**HARTZELL PROPELLER INC.**  
**SERVICE BULLETIN**  
**TRANSMITTAL SHEET**  
**HC-SB-61-304**

**Propeller - Introduction of an Improved Blade**

August 1, 2012

This page transmits a revision to Service Bulletin HC-SB-61-304.

**Figure 1**

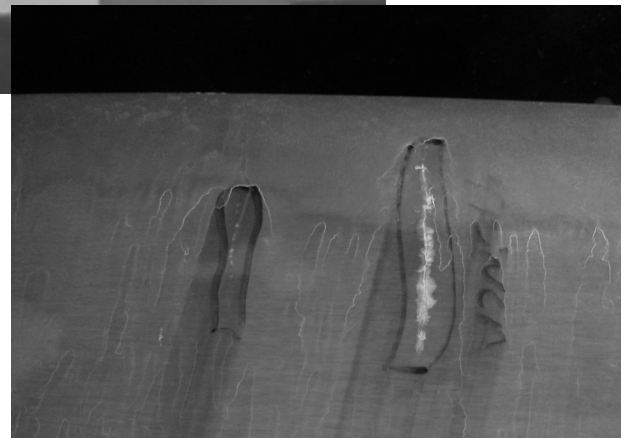
- (1) There have been sporadic reports of blade flutter during landing while using propeller reversing. An investigation identified a greater likelihood for this occurrence with blades nearing dimensional minimums.
  - (a) This same occurrence of blade flutter is also possible with blades near original manufacturing specifications.
  - (b) This condition can cause cracked and/or failed blades. Refer to Figure 1.

Cracks are located between the markings on the blades shown.

- (2) Blade Flutter can be identified by a large increase in sound level during application of reverse.
- (3) Blade replacement in accordance with the Compliance section of this Service Bulletin will minimize the tendency for flutter.
- (4) Replacement of all T10173F(N)(B,K)-12.5 blades with improved T10173AN(B,K)-12.5 blades is terminating action for this Service Bulletin.
- (5) Regulatory action is unknown.

**Blade Butt Showing Damage to Prevent Further Use of the Blade**  
**Figure 2**

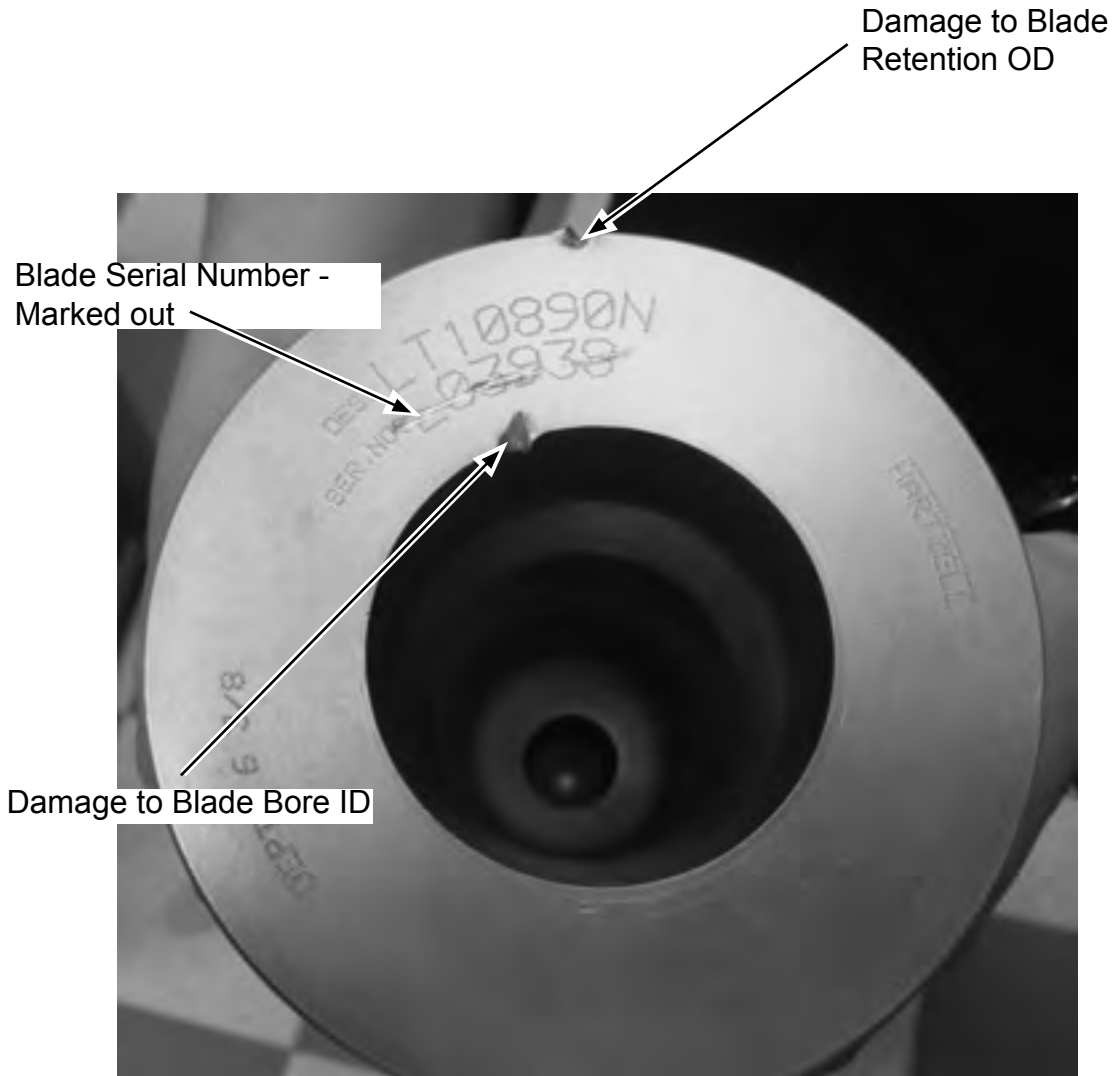
- 1      The retired blades cannot be modified or returned to service for use in any application, including experimental applications.
- 2      Each blade must be damaged in such a way that prevents further use of the blade.
  - 1      Using a tool, damage the ID of the blade bore and the OD of the blade retention surface. Damage must be sufficient to prevent installation of the blade bearing and the blade clamp. Refer to Figure 2.
  - 2      Mark out the blade serial number, so that the number is still legible.
  - 3      Take a photograph of the blade butt to show the damage, the blade model number, and the blade serial number. Refer to Figure 2.
  - 4      Send the photo via email to [techsupport@hartzellprop.com](mailto:techsupport@hartzellprop.com) in accordance with the Appendix to this Service Bulletin. **DO NOT RETURN THE BLADE.**
